PUBLIC NOTICE (07-20)

This public notice corrects inaccurate information contained in PN 08-19 dated 11 Dec 2019. In summary, PN 08-19 inaccurately stated a preliminary navigation determination vertical navigation clearance for any proposed fixed bridge needed to be greater than or equal to 176ft at OHW. The corrected information states that a Coast Guard preliminary navigation determination for vertical navigation clearance for any proposed fixed bridge needs to be greater than or equal to 162ft above the Columbia River Datum (CRD) or 147ft. above Ordinary High Water (OHW), $\text{OHW}=\text{CRD} + 15\text{ft}$. All other measurements have been updated to reflect vertical and horizontal navigation clearances referenced to CRD. All other information is the same.

The Commander, Thirteenth Coast Guard District has received a request for a Preliminary Navigation Determination (PND) from Multnomah County in preparation for compiling a Coast Guard Bridge Permit application for the Earthquake Ready Burnside Bridge project (EQRB). At the request of the Coast Guard, Multnomah County has prepared a navigation impact report (NIR) for the EQRB. Based off the EQRB NIR the Coast Guard is prep

Proposed fixed bridge minimum Navigation Clearance requirements at CRD (Columbia River Datum)

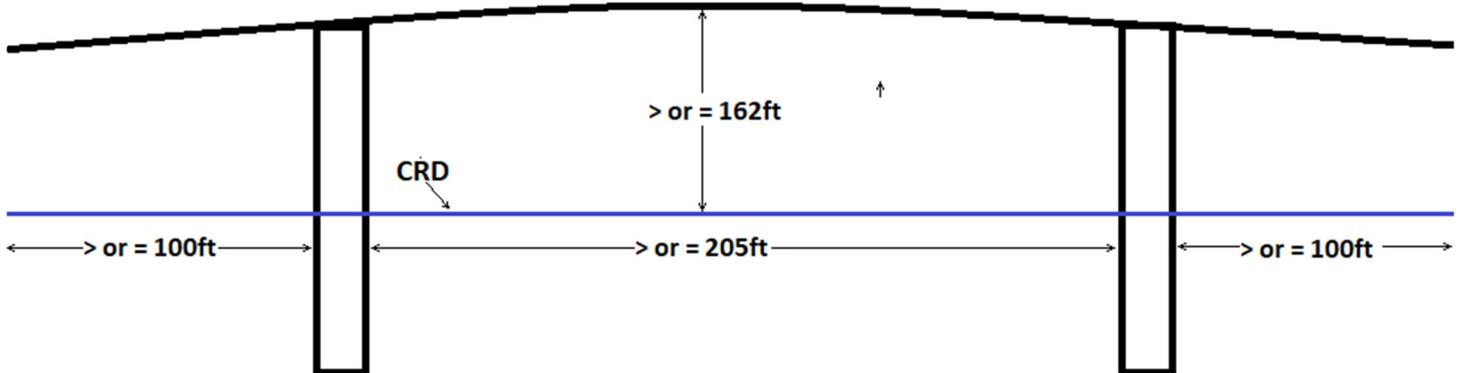
The bridge design below is not a proposed final bridge design. It only depicts the navigation clearance requirements necessary to obtain a U.S. Coast Guard bridge permit.
